NS-NRC-85-3025

Subject: BART-WREFLOOD Input Revision

## BART Vin ISSUE SUMMARY

COMPARISON OF INTEGRATED CORE INLET FLOW  
FIGURE 2

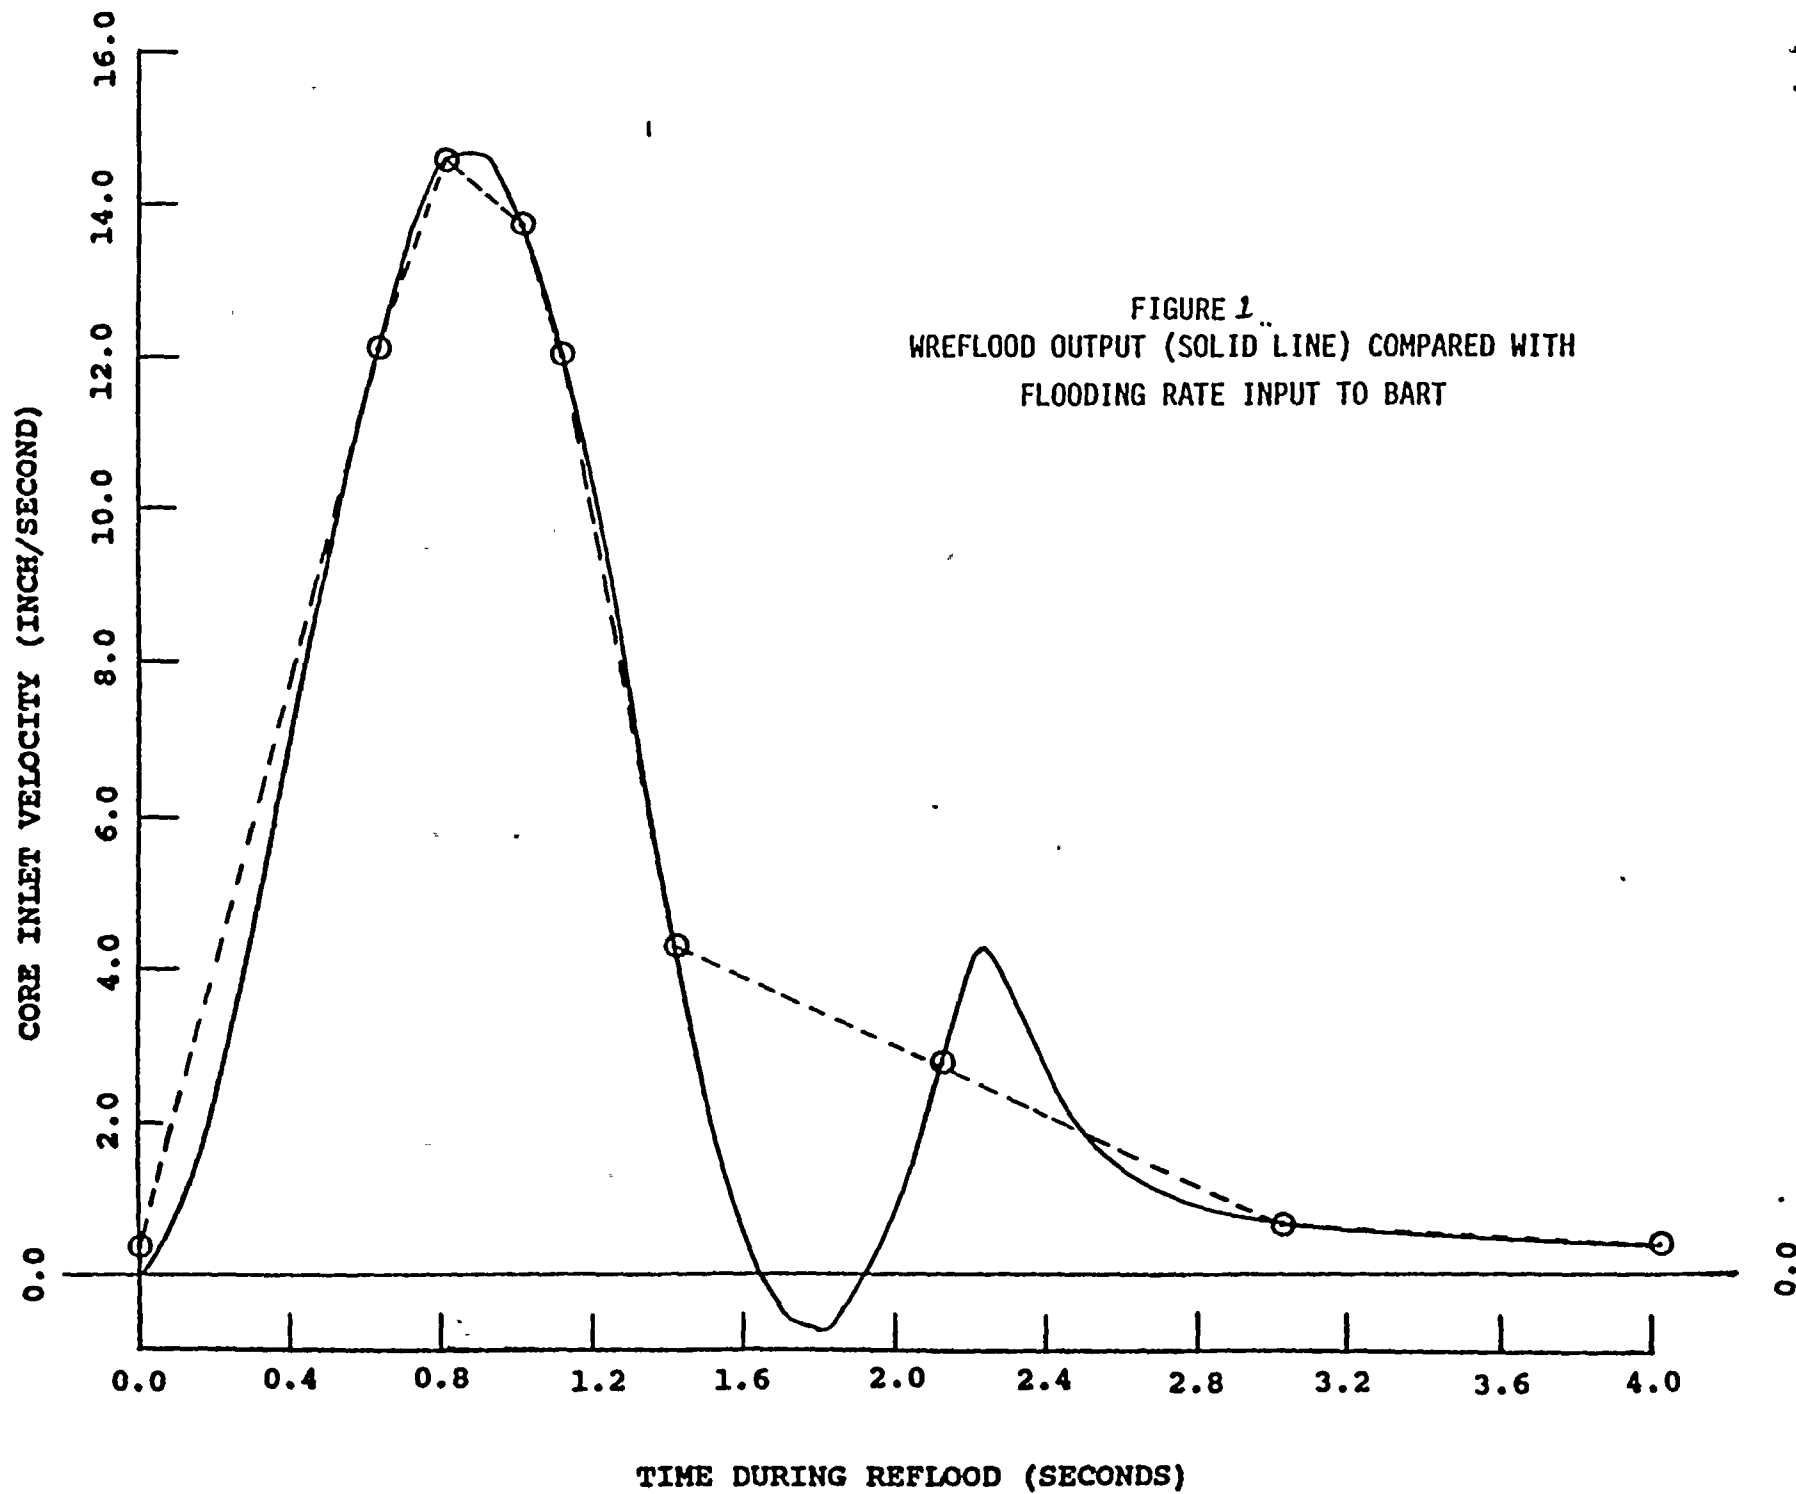
A limited number of instantaneous values of Vin are available to the analyst for replicating the Vin curve as a part of the BART input. Use of all available Vin values in the initial insurge portion of the transient does not necessarily produce good integrated agreement at the start of the second portion of the transient. Connecting the discrete input points can result in more water in the core than the WREFLOOD code calculates.

A representative example of WREFLOOD output and BART input is presented in figure 1. It can be seen that the area under the BART input Vin curve is greater than under the WREFLOOD output Vin curve. The BART points are the WREFLOOD values normally available to the analyst.

As a result the integrated value of water in the core may be higher in BART than in the WREFLOOD code. This higher water level provides an earlier onset of entrainment which results in an earlier initiation of steam cooling in the upper regions of the core. This earlier initiation of steam cooling gives a lower calculated PCT than would be calculated if the integrated value of the Vin curve from WREFLOOD had been matched exactly.

The WREFLOOD integrated Vin curve and the BART integrated Vin curve for a representative plant are presented in figure 2.

A data transfer procedure, utilizing the available WREFLOOD Vin output, has been developed and implemented that results in good agreement between the WREFLOOD calculated value of the integrated flooding rate and the BART calculated value of the integrated flooding rate. This procedure also cautions the analysis reviewer to verify the similarity of the integrated Vin curves between the two codes and provides a standard method for comparing the two curves.

A reanalysis of the Turkey Point Units 3 and 4 was performed using this new methodology. The results of this reanalysis indicated that the calculated PCT increased 79 F to 2051 F from the original analysis value of 1972 F.
